Recall Bulletin

PRODUCT SAFETY RECALL

SUBJECT: Driver's Airbag Module

MODELS: 2009-2010 Pontiac Vibe

3946766

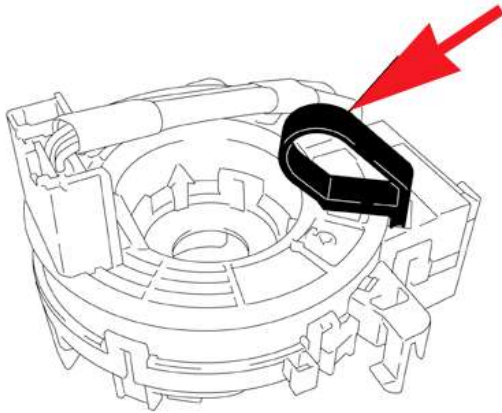
2. Apply the supplied grease to the two notches on the SIR coil as shown. Only use the supplied grease, do not substitute another lubricant.

3946767

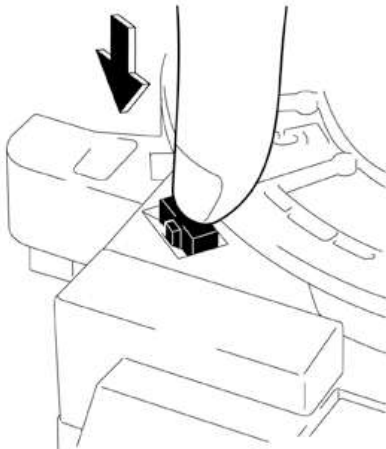
Note: DO NOT break off the lock pin until the steering wheel is installed. Otherwise, the center position of a new spiral cable will be misaligned. Ensure the pin is flush with the housing after it is snapped off.

If the pin is not flush, push the pin into the housing.
